Re: James & Mark Wright T/A (JMW Farms) ~ Licence Application P0696-03

I refer to previous Agency correspondence of 15th November 2023. Please find the response to the issues raised outlined below;

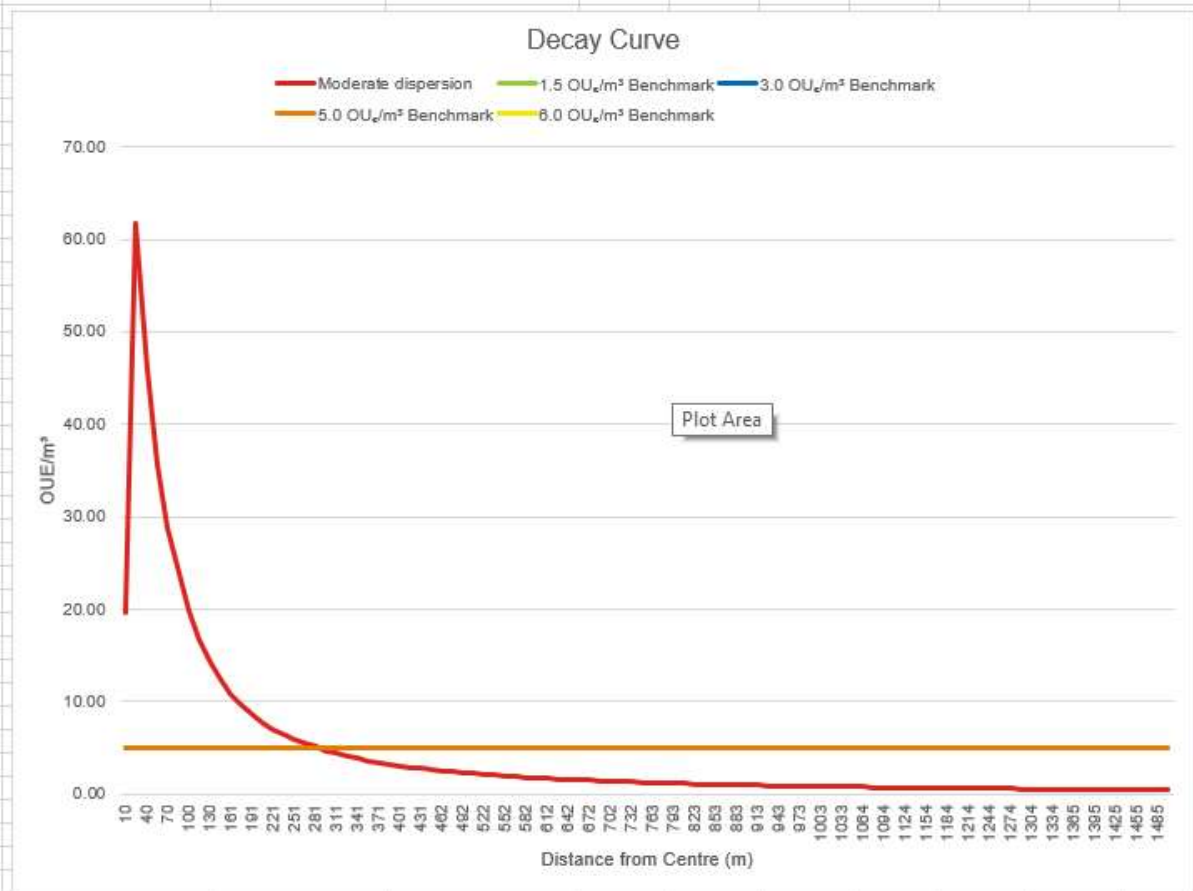
2. **Odour Assessment:** The EPA's odour screening tool has indicated that odour levels may exceed $5 \text{ OU}_E/\text{m}^3$ at nearby sensitive receptors. This is the odour limit that an existing installation licensed by the EPA between 2001 and 15th February 2017 must comply with.

- a. Have reference to the EPA's guidance document "Instruction note for the assessment of odour emissions from intensive agriculture pig installations" and the associated odour screening tool. Both can be found on the Agency's website at the following link: <https://www.epa.ie/publications/licensing--permitting/industrial/ied/instruction-note-and-screening-tool-for-the-assessment-of-odour-emissions-from-i.php>.
- b. Provide an assessment of the odour emissions from the activity and the impact on local residents. The required odour impact assessment should be undertaken in line with the approach outlined in the above-mentioned document and tool.

- d. The assessment should be supported by use of a model to predict odour concentrations at the sensitive receptors in the vicinity of the installation. The assessment should, as appropriate, identify odour reduction/mitigation measures.

Please see below the screenshots from the odour Modeling Tool. Note. Stock numbers included have been revised to provide the 30% reduction due to low protein diets.

It should be noted that the proposed licence review is to accommodate an existing permitted and operational pig house that is being assumed under the control of the existing licensed activity. In this regard the developments are already existing and operating without complaint, and there is no proposed change to the cumulative capacity of the existing pig farming activities.

The proposed licence amendment/review will;

- not result in any cumulative increase in odour and/or other emissions, and,
- due to the measures to be implemented to comply with BAT (and in particular low protein diets), result in a significant reduction in current emission levels,

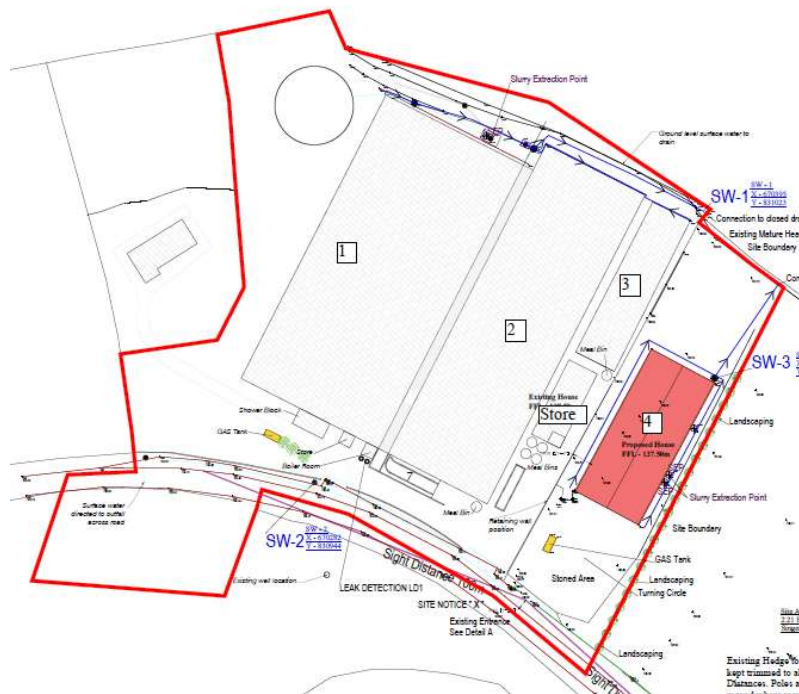
4. **Pig numbers:** Provide a breakdown of the proposed stocking numbers by animal category and by building, to include as a minimum, the numbers of dry sows, farrowing sows, weaners, and gilts/production pigs. Label each of these building on a site layout drawing.

Building	Predominant Animal Type	Quantity (no. of animals)
1	Farrowing	400
2	Dry sows	800
2	Gilts	315
1	Weaners	6800
3	Maiden Gilts	235
4	Growers	400
4	Finishers	600
